| Form 3160-5 (June 2015) | UNITED STATES | | OMB N | APPROVED IO. 1004-0137 anuary 31, 2018 |
| Change well name/numb Uffect | er to: Stella Blue 30 Fed Con | n 702H - 30000 | AUG 07 2 | 018 |

Revised Permit Information 5/17/18:

Well Name: Stella Blue 30 Fed Com No. 702H

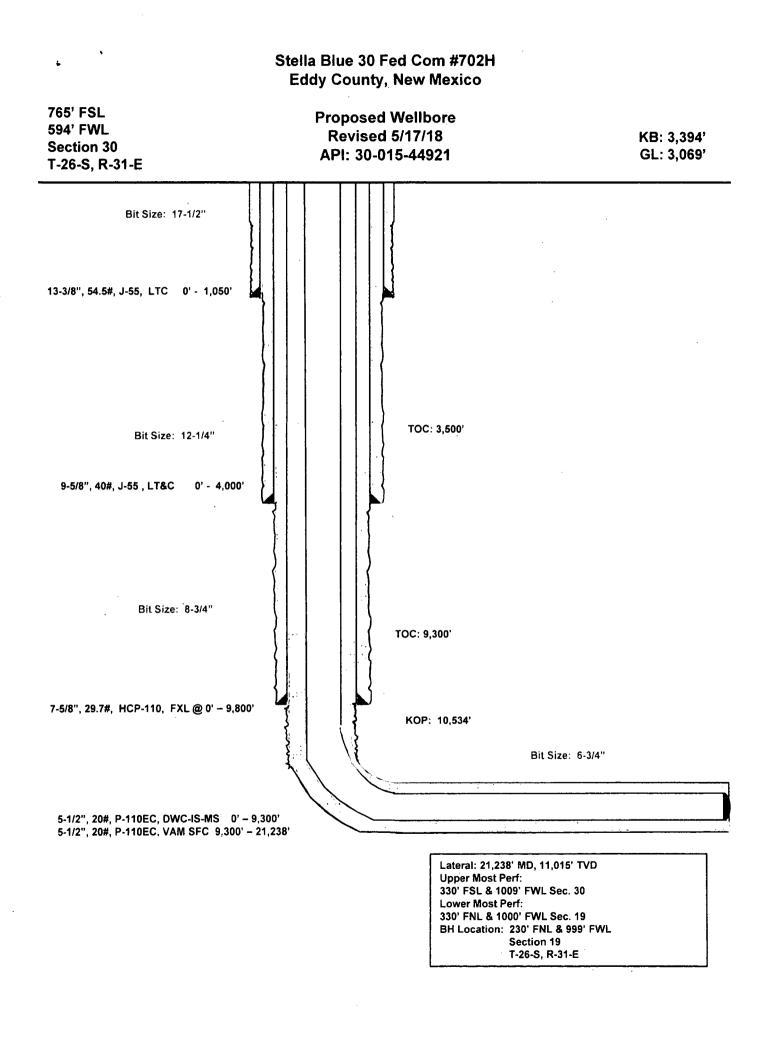
| Form 3160-5 (June 2015) | UNITED STATES | | OMB N | APPROVED IO. 1004-0137 anuary 31, 2018 |
|---|--|---|--|--|
| determined that the site is ready EOG Resources requests and well name. | | ved APD for this well to reflect | t changes in casing RECEIVE D | t. |
| Change casing to 4-string |) as attached. | | | |

Variance is requested for annular clearance of the 5-1/2" x 7-5/8" to the top of cement.
